Re: APSC Docket No. 07-016-U
Entergy Arkansas, Inc. 2012 Integrated Resource Plan

Entergy Arkansas, Inc. 2012 Integrated Resource Plan

**Entergy Arkansas, Inc.,
Integrated Resource Plan
Stakeholder Report**

Figure 1: Entergy and Henry Hub Natural Gas Forecasts and Futures

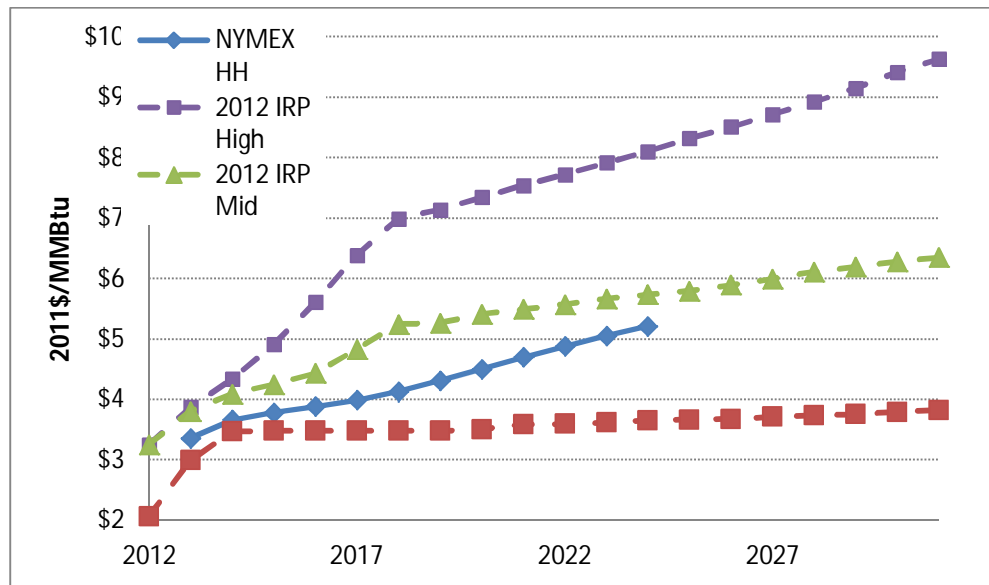
Natural-gas prices affect many important resource decisions, including whether to refurbish Entergy Arkansas’s existing gas steam units and whether to spend hundreds of millions of dollars to keep the White Bluff and Independence coal plants in operation. The mid-range Henry Hub gas prices used in Entergy’s IRP are considerably higher than current futures prices; see Figure 1.¹ Through 2019, the futures prices are closer to Entergy’s low prices than its mid-range prices.

Both the NYMEX market participants and Entergy’s forecasting staff attempt to capture much the same set of considerations (resource potential, changing technology, environmental regulations, demand from consumers, power generation, and exports). However, it is important to recall that the NYMEX prices are real prices, produced by the combined projections of a large

Second, Entergy understated the benefits of measures that save both gas and electricity by using an avoided gas cost of “\$0.386/ccf in 2011 and escalated at 2.0% per year” (Response 3-15). This is about \$3.77/MMBtu in 2011 dollars. Both Entergy gas-price forecasters and the NYMEX market participants are expecting prices much higher than \$3.77/MMBtu in 2011 dollars within a couple years (see Figure 1). Since most gas at retail is used in the winter, when prices are higher than the average over the year, and since gas utilities need to maintain reserve capacity for extreme cold snaps, the avoided retail gas cost should be considerably higher than the annual market prices shown in Figure 1.

Figure 2: Natural Gas Forecasts, Docket 09-024-U and Today

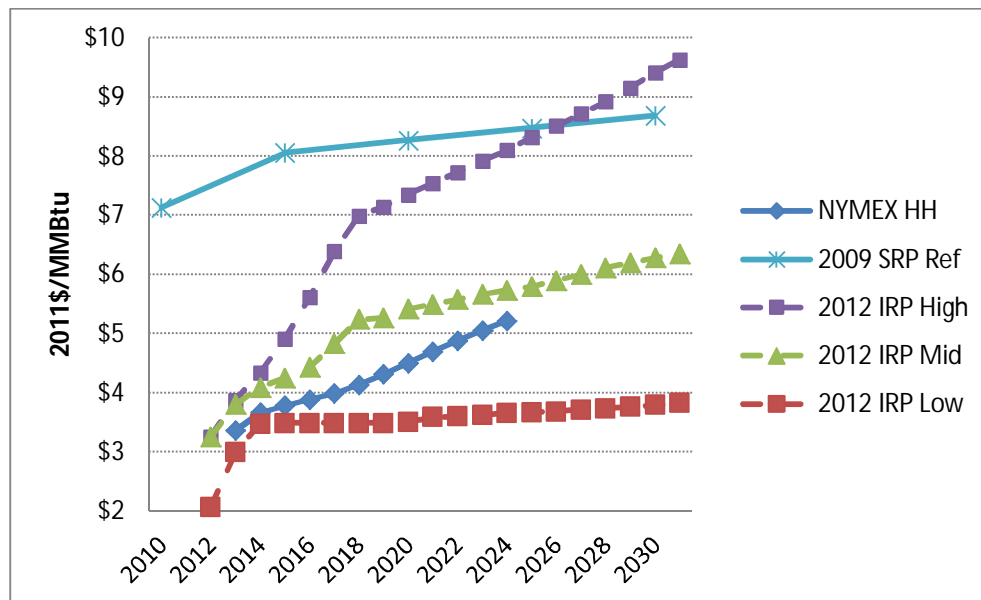
In terms of natural-gas prices, Entergy's analysis in Docket No. 09-024-U used price forecasts contemporaneous with Entergy's 2009 System Resource Plan. Figure 2 compares the reference gas prices from the 2009 SRP to the gas prices that Entergy (2012a, 10) projected in the 2012 IRP presentation. The 2009 reference-price forecast was greater than the current high forecast

through 2025 and was more than \$2.50/MMBtu greater than the current mid-range gas forecast through the forecast period.

Revising the 2009 gas prices to current expectations would almost certainly eliminate any economic benefit from continued operation of the coal plants, even with optimistic assumptions about required environmental retrofits.
